ChipSHOUTER CW521 Ballistic Gel

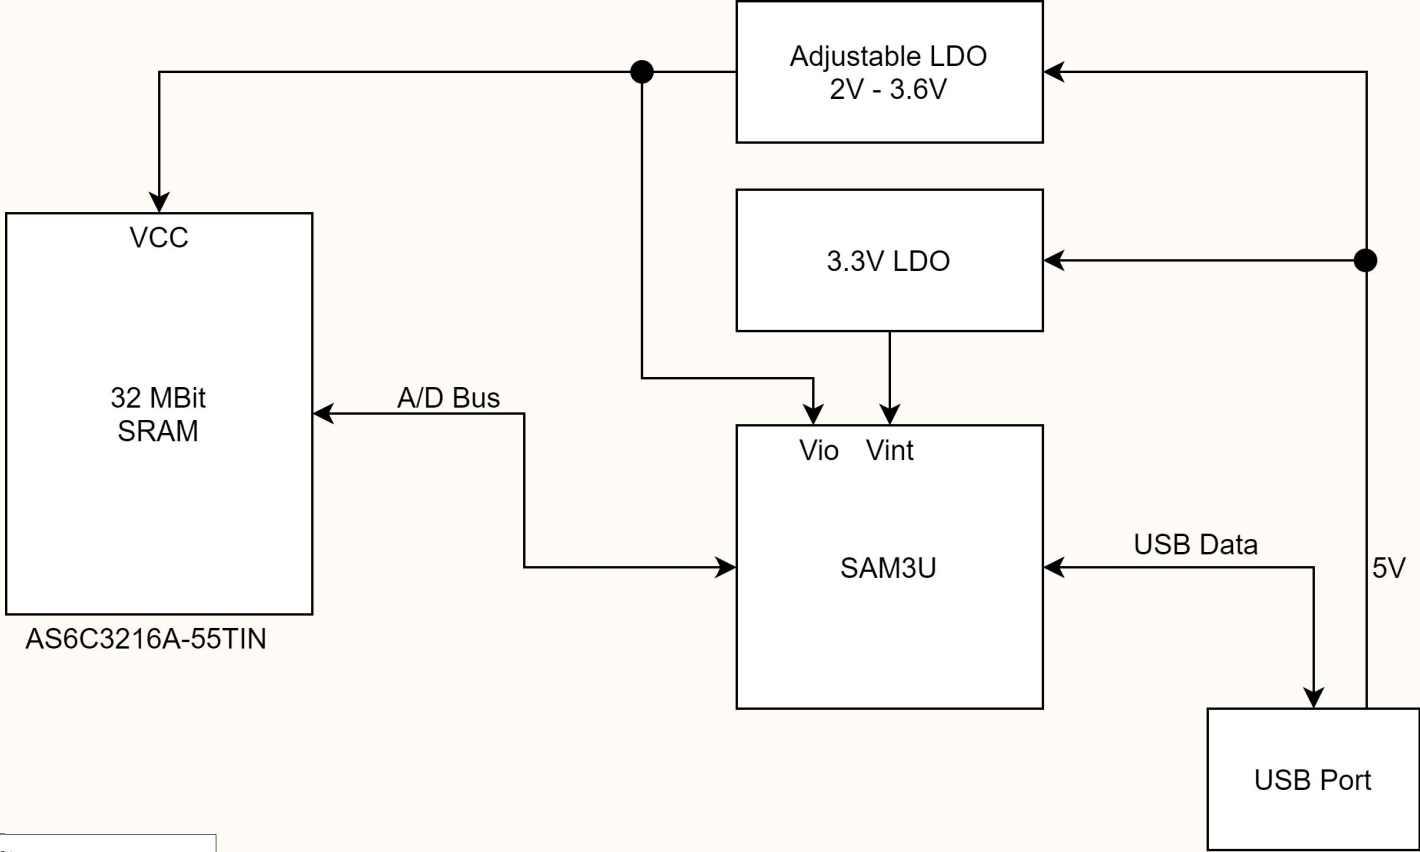
Rev 03 to Rev 04 Changes:  
\* Fix USB resistor, allow USB HS to work.  
\* Switch all parts to top-side of PCB.

Rev 01 to Rev 02 Changes:  
\* Add pull-up on RST net  
\* Connect switch to NRST  
\* Fix power-on MOSFET  
\* Add LED on target power  
\* Add more power filtering  
\* Add missing SRAM address pins
